APPLICATION NO.	FILING DATE	FIRST NAMED INVENTOR	ATTORNEY DOCKET NO.	CONFIRMATION NO.
10/038,678	01/08/2002	Toyoki Taguchi	217895US-2S DIV	9814
22850	7590	03/10/2004	EXAMINER	
OBLON, SPIVAK, MCCLELLAND, MAIER & NEUSTADT, P.C. 1940 DUKE STREET ALEXANDRIA, VA 22314			LEUNG, QUYEN PHAN	
			ART UNIT	PAPER NUMBER
			2828

Office Action Summary

FIG. 15

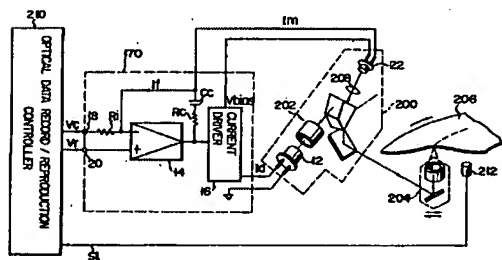
3. Claims 7-20 are rejected under 35 U.S.C. 102(b) as being anticipated by Taguchi (5,097,473). Taguchi discloses the claimed invention. Note figure 15 which shows a semiconductor laser (12), a light intensity detection element (22), an amplifying circuit (14) a laser drive circuit (16), and a modulation signal current generating section (210) for outputting a modulating signal current (record pulse signal, see col. 11 lines 32-57, below) to the reversal input terminal (-) of the amplifying circuit (14).
